Work Order ID 98214

Item Name: Crosstube Fwd Extended

DRAWING NO. D205-596-105	TITLE CROSSTUBE	REV. B	DART AEROSPACE LTD ENGINEERING ORDER		D.E.O. NO. D205-596-105-B-1	SHEET NO. SHEET 1 OF 1	SCALE NTS
DRAWN <i>UP</i>	CHECKED <i>PH</i>	MFG. APPR. <i>AA</i>	APPROVED <i>AD</i>		DE APPR. <i>AD</i>		
DATE 09.05.01	DATE 09.06.15	DATE 09/06/22	DATE 09/06/22		DATE 09.06.22

DRAWING NO. D205-596-105	TITLE CROSSTUBE ASS'Y, HI-HI FWD	REV. B	DART AEROSPACE LTD ENGINEERING ORDER		D.E.O. NO. D205-596-105-B-2	SHEET NO. SHEET 1 OF 1	SCALE NTS
DRAWN <i>q</i>	CHECKED <i>A.P.</i>	MFG. APPR. <i>A</i>	APPROVED <i>MD</i>	DE APPR. <i>HA</i>			
DATE 13.11.11	DATE 13.11.14	DATE 13.11.14	DATE 13/11/21	DATE 13/11/21

FIGURE 1 - SUPPORT INSTALLATION

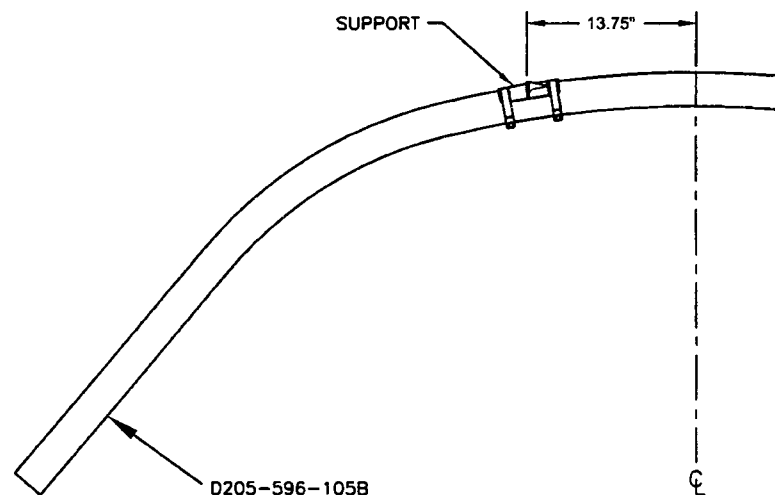
CHANGE:

ADD THE FOLLOWING CROSSTUBE ASSEMBLY:

Part Number	Description
D205-596-105B	CROSSTUBE ASSEMBLY (214 HI-HI FWD)

THE D205-596-105B CROSSTUBE HAS THE SAME PARTS LIST AS THE D205-596-105 CROSSTUBE. HOWEVER, INSTALL THE SUPPORTS AS SHOWN IN FIGURE 1 OF THIS ENGINEERING ORDER. THE NEW KIT IS OTHERWISE ASSEMBLED PER THE D205-596-105 CROSSTUBE.

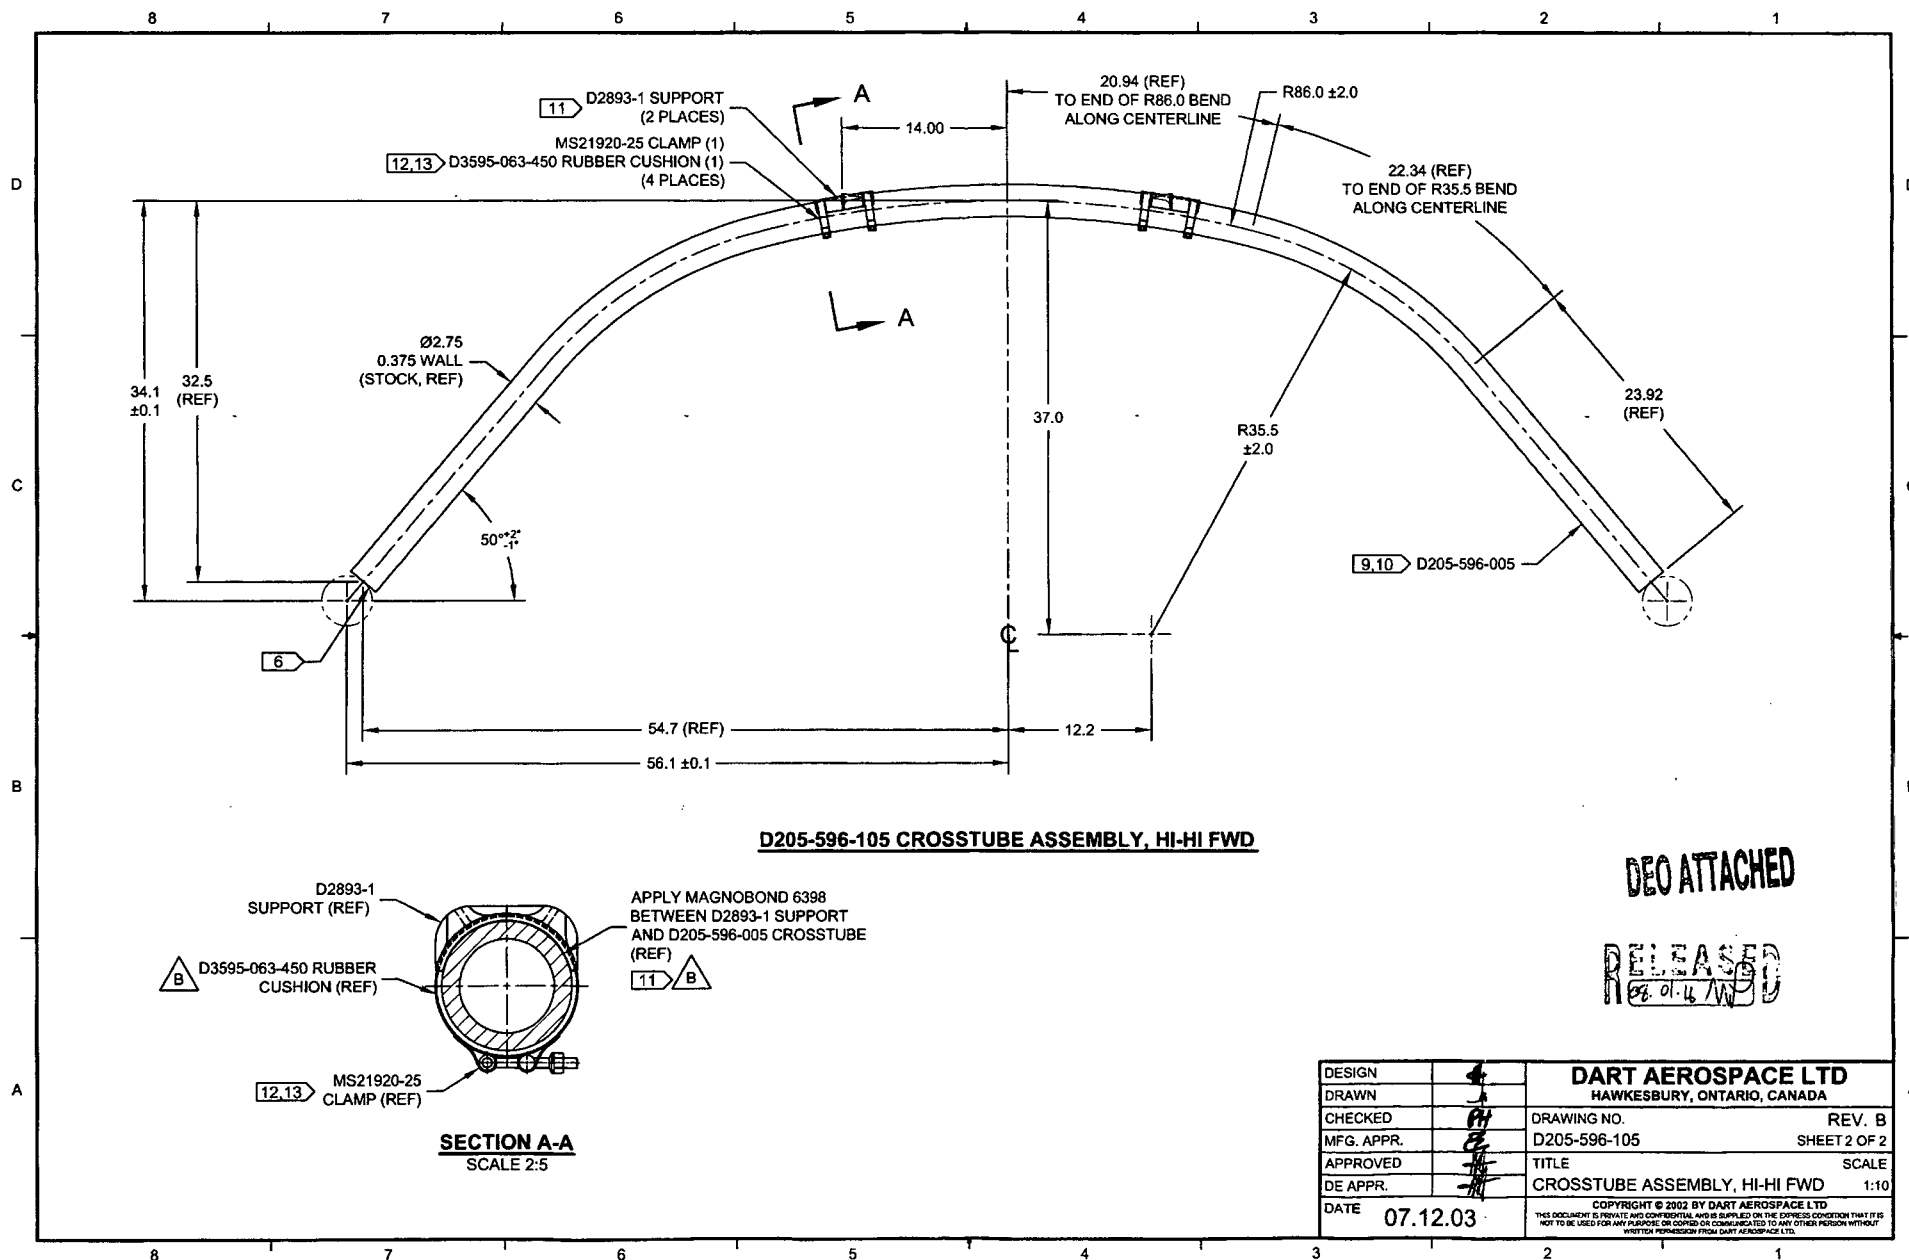
PURPOSE:

REPLACE MAGNOBOND WITH PROSEAL.

NOTE 11 & 13, SHEET 1 IS AMENDED AS FOLLOWS:

WAS:

- 11) APPLY A 0.03" TO 0.06" THICK LAYER OF MAGNOBOND 6398 TO THE SURFACE OF D2893-1 THAT WILL BE IN CONTACT WITH THE CROSSTUBE. LET CURE FOR 12 HOURS AFTER INSTALLATION AND PRIOR TO PACKAGING.
- 13) TORQUE CLAMPS 80 TO 100 IN-LB.

IS:

- 11) TO INSTALL D2893-1 SUPPORT: ABRASE MATING SURFACE OF SUPPORT AND CROSSTUBE WITH 180-GRIT SANDPAPER AND REMOVE RESIDUE WITH MEK (OR EQUIVALENT). APPLY A 0.04" TO 0.07" THICK LAYER OF PROSEAL 890 CLASS B-2 (OR AMS-S-8802 CLASS B-2) SEALANT TO MATING SURFACE OF SUPPORT.
- 13) TORQUE CLAMPS 80 TO 100 IN-LB. ENSURE AT LEAST 1.5 THREADS SHOWING IN SAFETY AND THAT NUT HAS NOT BOTTOMED-OUT AFTER TORQUING. PRIOR TO PACKAGING, RE-CHECK TORQUE ON CLAMPS AFTER PROSEAL 890 SEALANT HAS CURED FOR 72 HOURS.

FIGURE 1 - SUPPORT INSTALLATION

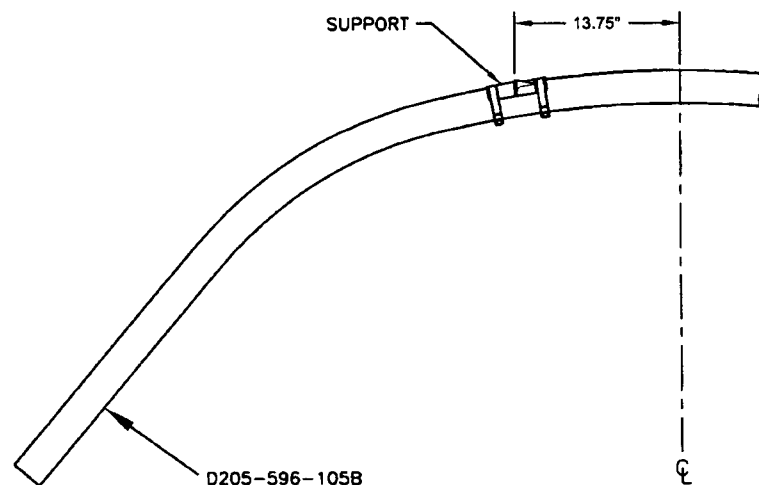
CHANGE:

ADD THE FOLLOWING CROSSTUBE ASSEMBLY:

Part Number	Description
D205-596-105B	CROSSTUBE ASSEMBLY (214 HI-HI FWD)

THE D205-596-105B CROSSTUBE HAS THE SAME PARTS LIST AS THE D205-596-105 CROSSTUBE. HOWEVER, INSTALL THE SUPPORTS AS SHOWN IN FIGURE 1 OF THIS ENGINEERING ORDER. THE NEW KIT IS OTHERWISE ASSEMBLED PER THE D205-596-105 CROSSTUBE.
